WATTS BAR NUCLEAR PLANT (WBN) UNIT 1 - RESPONSES TO REQUEST FOR
ADDITIONAL INFORMATION (RAI) REGARDING TRITIUM PRODUCTION -
INTERFACE ITEM NUMBER 3 - COMPLIANCE WITH DNB CRITERION - TAC
NO. MB1884

ENCLOSURE
TENNESSEE VALLEY AUTHORITY
WATTS NUCLEAR PLANT (WBN)
UNIT 1
DOCKET NO. 390
RESPONSE TO NRC'S REQUEST FOR ADDITIONAL INFORMATION

FIGURE 3.1
RESULTS OF ANALYSIS OF CONDITION I POWER SHAPES

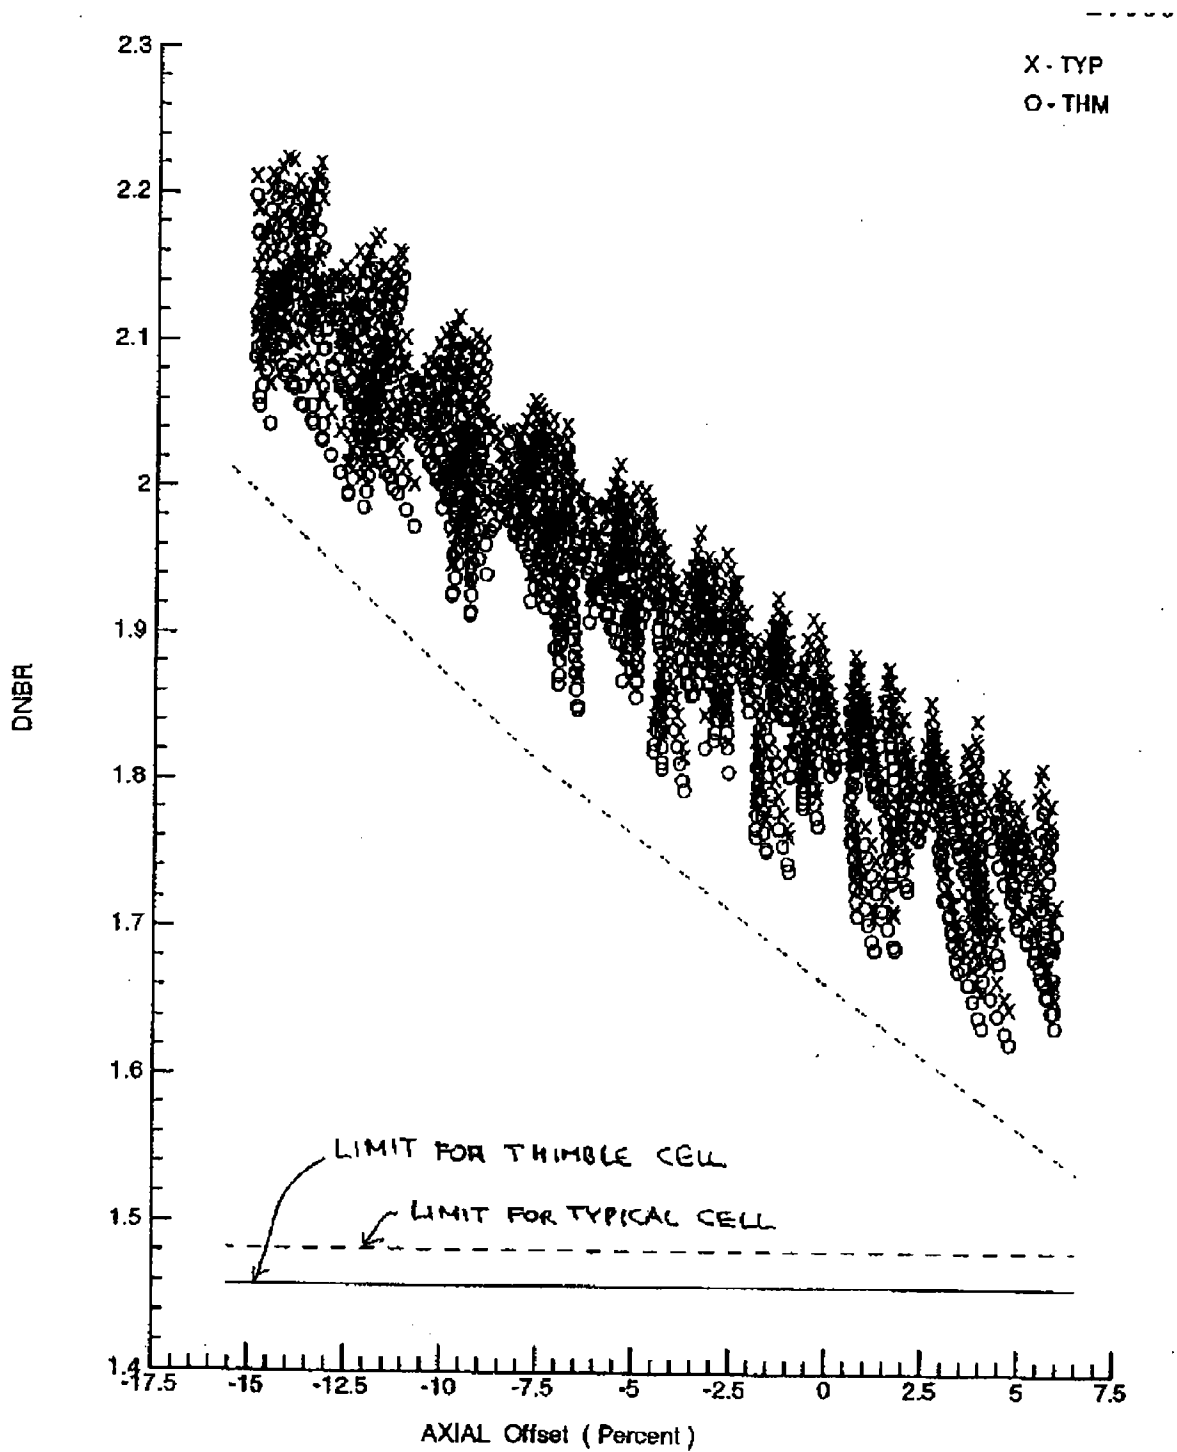
For the comparisons stated in the first paragraph of Section 2.4.4.5, on page 2-28, please provide the results of the comparisons (i.e., plots, sketches, etc.)

1. There is margin to the Condition I axial power shape used for the analysis of transients starting from normal operation at full power (See Figure 3.1.) and

Figure 3.1 shows the results of the analysis of the Condition I axial power shapes for an equilibrium core of TPBARs. Each circle or x corresponds to a power shape.
